### NFPA Technical Committee on Means of Egress (BLD/SAF-MEA) NFPA 101 & NFPA 5000 First Draft Meeting (A2026)

July 11 – July 12, 2024  
8 a.m. (CT)

**7.2.1.2.4 Door Leaf Height.**

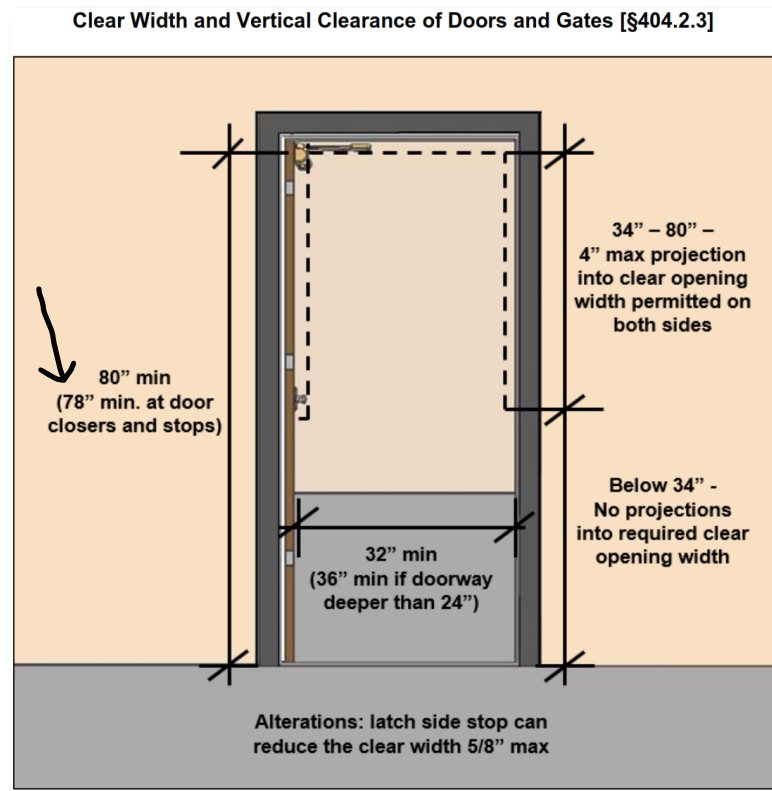
Insert new section after 7.2.1.2.3.2 (and revise title of 7.2.1.2):

Also, the title of 7.2.1.2 perhaps should be revised: **7.2.1.2 Door Leaf Width and Height.**

Doors in the means of egress shall be not less than 80 in. (2030 mm) in clear opening height.

Projections into the required clear opening height by door closers, overhead door stops, door frame stops, power door operators, and electromagnetic door locks shall be permitted a minimum of 78 in. (1980 mm) above the floor.

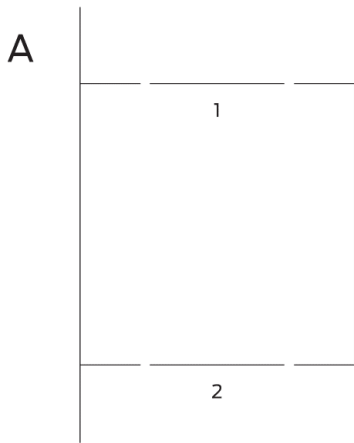
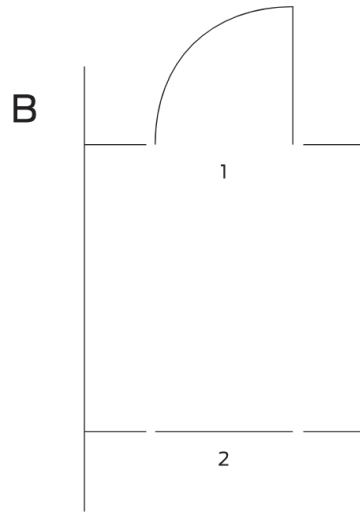
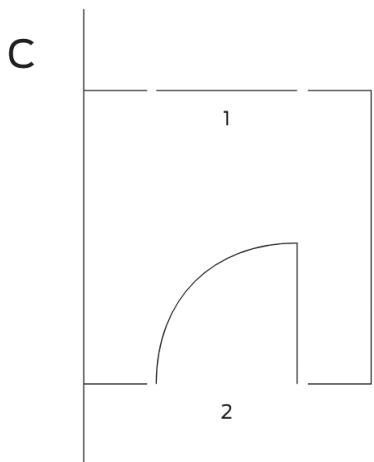
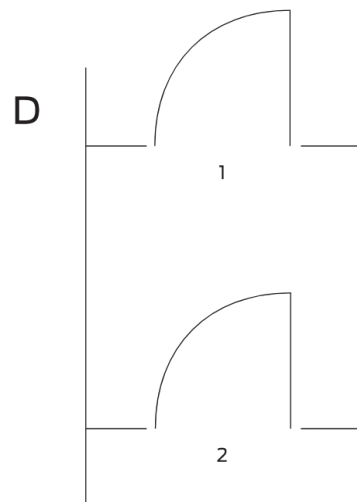
This proposal, along with complementary proposals in Chapters 18, 19, 20, 21, 36, 37, 38, 39, 40, and 42 offer the opportunity for interlocked-door vestibules in these occupancies.

This proposal addresses the egress aspects of interlocked-door vestibules. Ingress and controlling access into a building or space is not addressed by these proposed provisions.

An occupant egressing through an interlocked-door vestibule would not be delayed at the second door in series if the first door in series is in a closed position. Conversely, if the first door is not closed, the second door would not be able to be opened. The proposed requirements for interlock override switches, for “fail-safe” interlocks in the event of power failure, and to deactivate the interlock upon activation of the sprinkler system or smoke detection system are all intended to ensure unencumbered egress when and if needed.

An interlocked-door vestibule, which may also be known as an airlock, interlock, or man-trap, can help limit the passage of contaminants by allowing only one door to be open at a time, or controls access to and egress from an area for security reasons (such as in a data center or prescription drug dispensary). This image illustrates one of the common applications, an interlocked-door vestibule serving a clean room in a laboratory environment. Air-flow in or out is limited with normal operation as only one door may be opened at a time. In an emergency, both doors may be opened simultaneously, via the override switch beside each door.

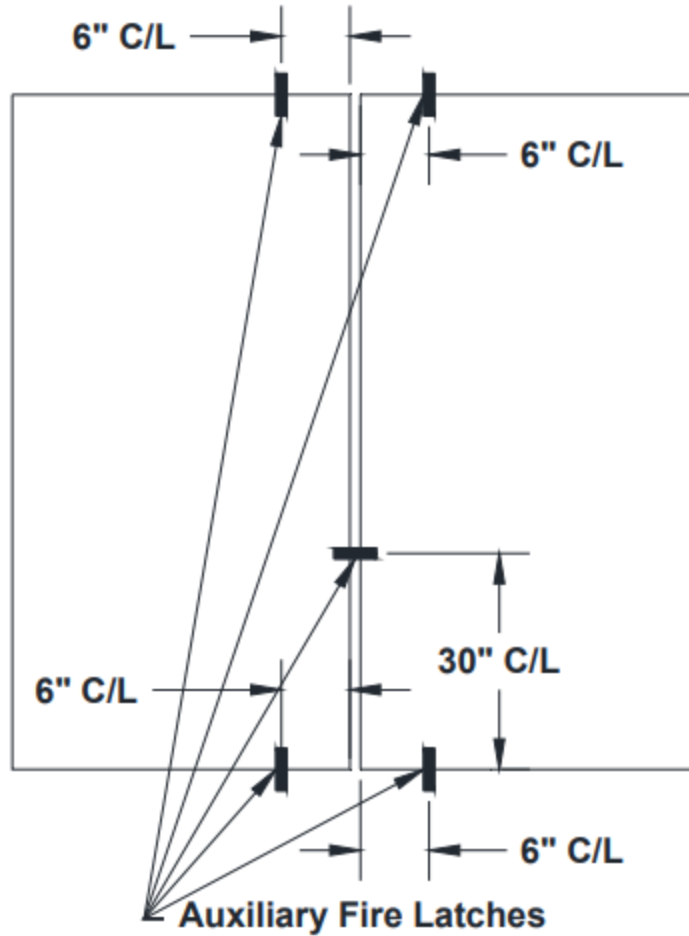
Section 7.2.1.5.5 exempts fire-rated doors exposed to elevated temperatures of fire from being operable when the building is occupied. A.7.2.1.5.5 explains that auxiliary latches (aka fire and thermal pins) render doors inoperable after exposure to fire. Auxiliary latches have been in use since at least the early 1990s, and their use is ubiquitous today. However, the Code does not currently contain provisions and requirements for using auxiliary latches. Accordingly, this proposed new section addresses the installation and use of auxiliary latches when used on certain fire-rated doors equipped with fire exit hardware. The quantity, orientation, and placement of auxiliary latches on pairs of doors vary based on the internal construction of the doors and how the manufacturers tested the doors by a nationally recognized testing laboratory (NRTL). While many pairs of fire-rated doors require a single auxiliary latch, other pairs of fire-rated doors require two or more, even up to five auxiliary latches on certain assemblies (see the attached files for examples from one door manufacturer). Pairs of wood and wood-composite fire-rated doors generally require more auxiliary latches than hollow metal (aka steel) fire-rated doors.

Unlike other types of positive latching hardware components, in their normal state (i.e., the captured pins are held retracted by fusible coverings), auxiliary latches are not operable by occupants; they only project after their fusible coverings melt when exposed to temperatures of approximately 400°F or greater, releasing the pins and causing them project under spring power. Once projected, they cannot be retracted; fixing the door panels closed to maintain the integrity of the fire barriers and walls in which they are installed. Consequently, auxiliary latches are not subject to the Code's range of mounting heights for operable latching hardware components.

<u>File Name</u>	<u>Description</u>	<u>Approved</u>
NFPA_101_First_Draft_Fig_A.7.2.1.8.2.docx	Proposed fig for closing speed of self-closing doors.

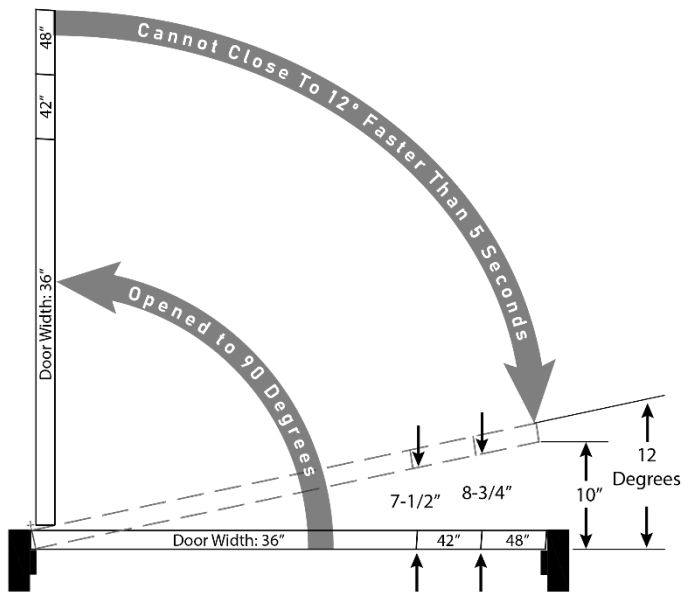
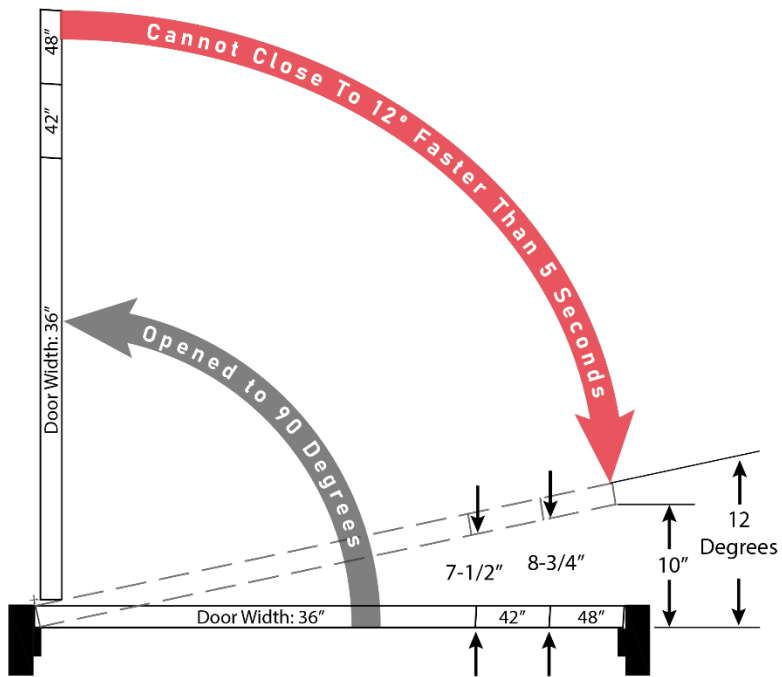
The proposed new section clarifies the Code's closing speed requirement for self-closing doors. Many self-closing doors are required to comply with the conditions of A117.1, but certain conditions such as the closing speed of doors are unspecified in the Code. The door inspection requirements of 7.2.1.14.6, specifically item (6), requires the closing speed of doors to comply with accessibility requirements. However, NFPA 101 does not contain provisions and requirements regarding the closing speeds of self-closing doors.

This proposal seeks to add A117.1's closing speed limitations for self-closing doors to complement the inspection and testing requirement of 7.2.1.14.6(6).

**Figure A.7.2.1.2.2(b) Door Width — Egress Capacity with Permitted Obstructions. Egress Capacity Width Measurement with Boundary/Edge Effect Clearances**

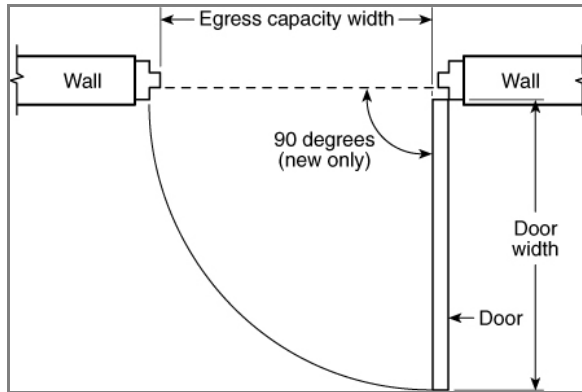
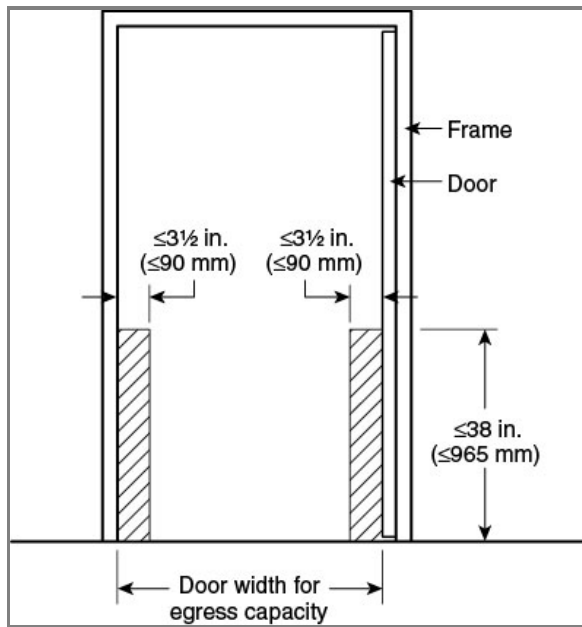
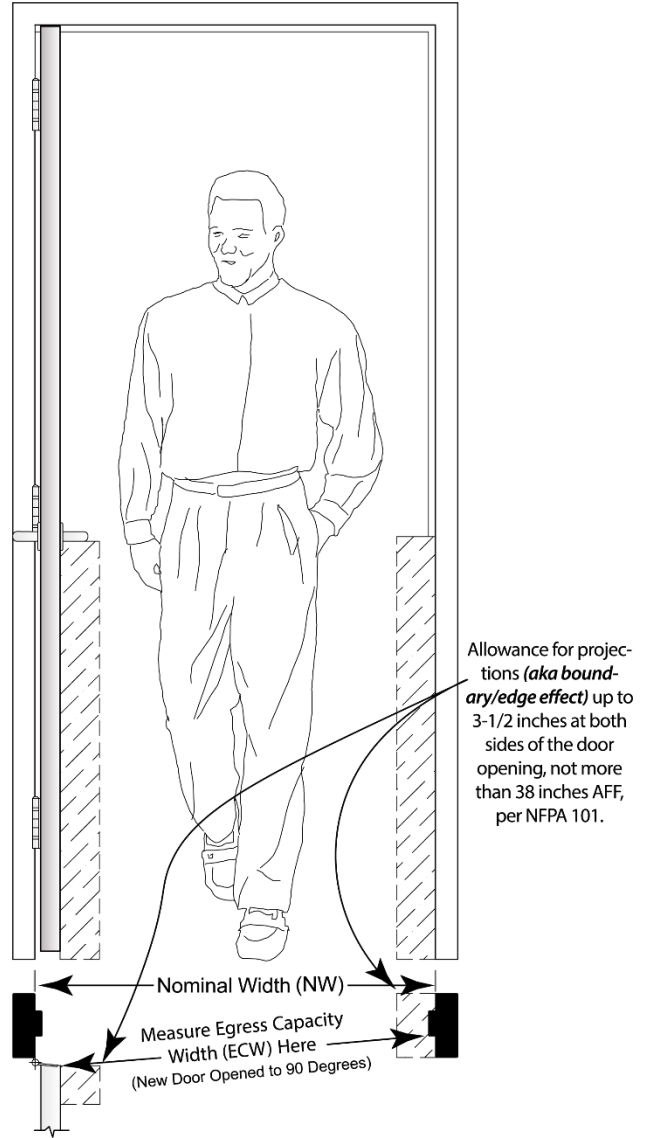
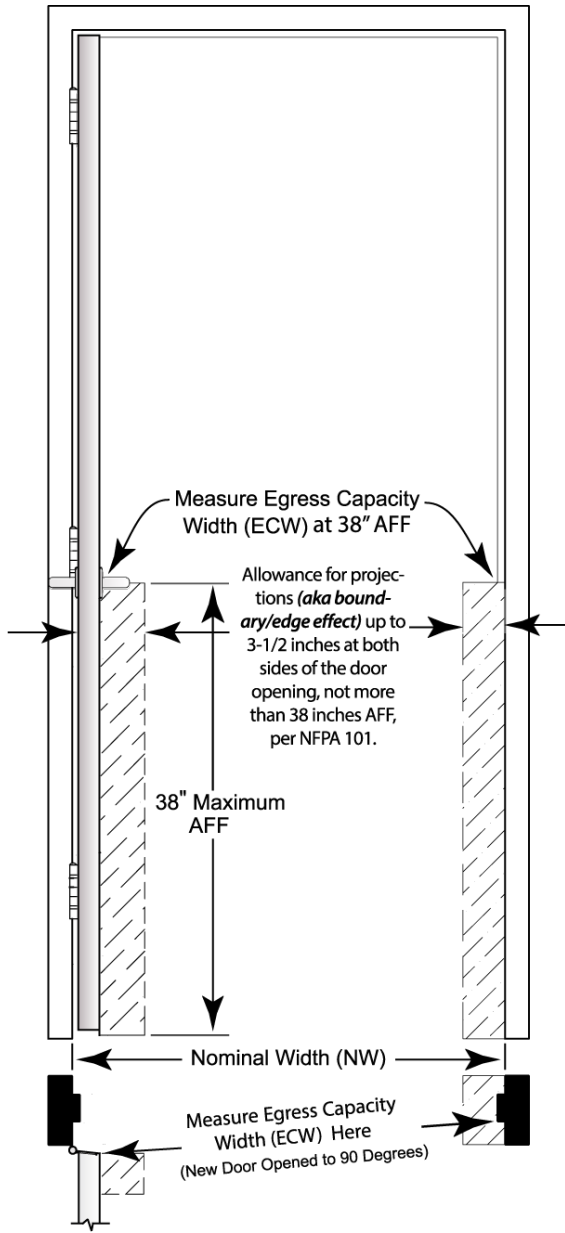
<<REPLACE FIGURE A.7.2.1.2.2(b) with ONE OF THE ATTACHED FIGURES>>

Existing Figure A.7.2.1.2.2(b) seems to allow for unspecified physical obstructions when measuring egress capacity widths of door openings, which creates confusion in the field. Unlike the 4-inch projection for fire exit hardware and panic hardware devices, these 3-1/2-inch encroachments at both sides of the door opening are not for tangible door hardware or other materials. Instead, they apply the effective-width concept of building elements such as corridors, ramps, stairs, and doors referred to as the boundary/edge effect described in NFPA 101. (See paragraphs 7.3.2.2, 7.3.3.2, and A.7.3.3.2.)

The first paragraph in A.7.3.3.2 includes the following statement: "In essence, the effective width phenomenon recognizes that there is an edge or boundary effect at the sides of a circulation path..." The unspecified projections shown in Figure A.7.2.1.2.2(b) illustrate the boundary/edge effect as it pertains to door openings.

Essentially, the boundary/edge effect accounts for the human body's shape; we're narrower at our feet and wider at our shoulders. Consider how we walk through doorways; we tend to walk through the center area of the openings. Our feet create a natural clearance between the side jambs of the door frames as we step through the openings; otherwise, we would kick the frames with our feet and our shoulders would rub against them. The boundary/edge effect accounts for this naturally occurring clearance. The boundary/edge effect applies only to where the measurement for the egress-capacity calculation of swinging doors is taken; it does not reduce the clear width dimension requirement for swinging doors. The Code requires swinging egress doors to provide the minimum clear width dimensions for the occupancies they serve. Projections into the required clear width dimensions below thirty-four (34) inches above the finished floor (AFF) are not permitted.

Adopting one of the submitted figures (or a version thereof) to replace the existing figure clarifies the Code's intent.
